Sling Aircraft (Pty) Ltd
Registration no 2002/022837/07
Approved Maintenance Organisation AMO1264
Manufacturing Organisation M677

SERVICE BULLETIN

#0023

SUBJECT: Incorrect Nose Gear Bolt Replacement

Figure 1: Correct Nose Gear Bolt thread length

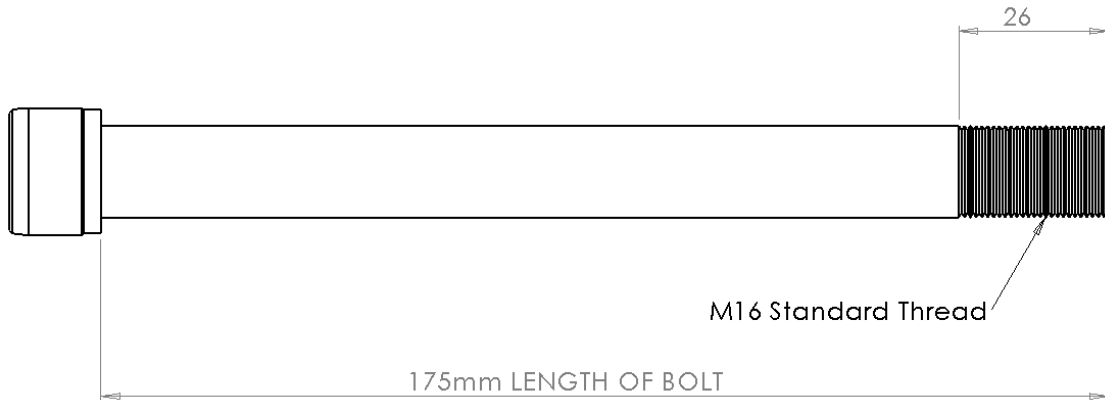
The threaded section on the nose gear bolt provided to the affected aircraft is too long. This results in the threaded section of the bolt being loaded and may make the bolt more likely to fatigue and/or possibly break with a rough landing. This bolt needs to be replaced with one of the correct thread length to ensure that the thread does not get loaded.

Figure 1 shows the correct nose gear bolt dimensions. The nose gear bolt (HW-MCB-612-X-X-0) dimensions should be checked and if the bolt's thread length is incorrect it must be replaced with a new bolt of the correct dimensions. These bolts can be ordered from Sling Aircraft.

Figure 4: Nose gear wheel assembly

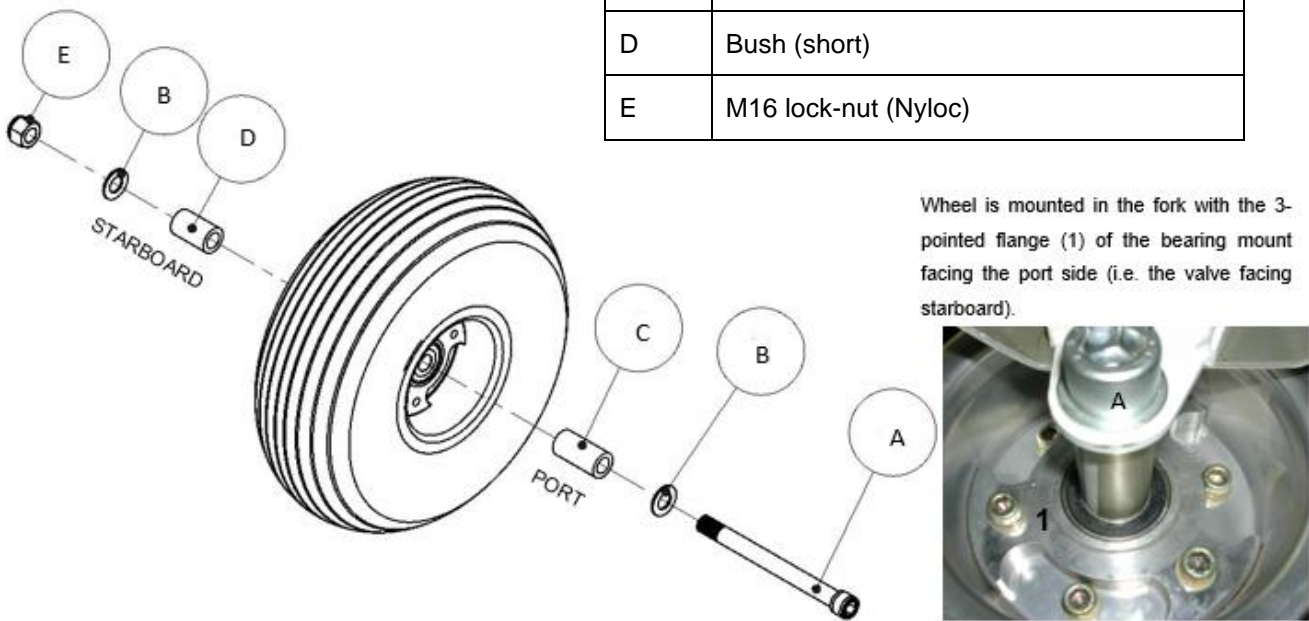
Step 1: In order to install the new replacement bolt with the correct thread length, reverse the procedure specified in Section 3.1. Ensure that the assembly of the wheel get reassembled correctly. Refer to the exploded view of the wheel axle assembly to ensure the components get placed in the correct positions, refer to Figure 4.

Wheel is mounted in the fork with the 3-pointed flange (1) of the bearing mount facing the port side (i.e. the valve facing starboard).

- Step 2: Torque the M10 Allen cap bolt to 10.5 Nm.
- Step 3: Apply torque seal into the bolt.
- Step 4: Verify free rotation for the wheel.
- Step 5: Apply Loctite 222 to the failing screws and reinstall the nose gear fairing.
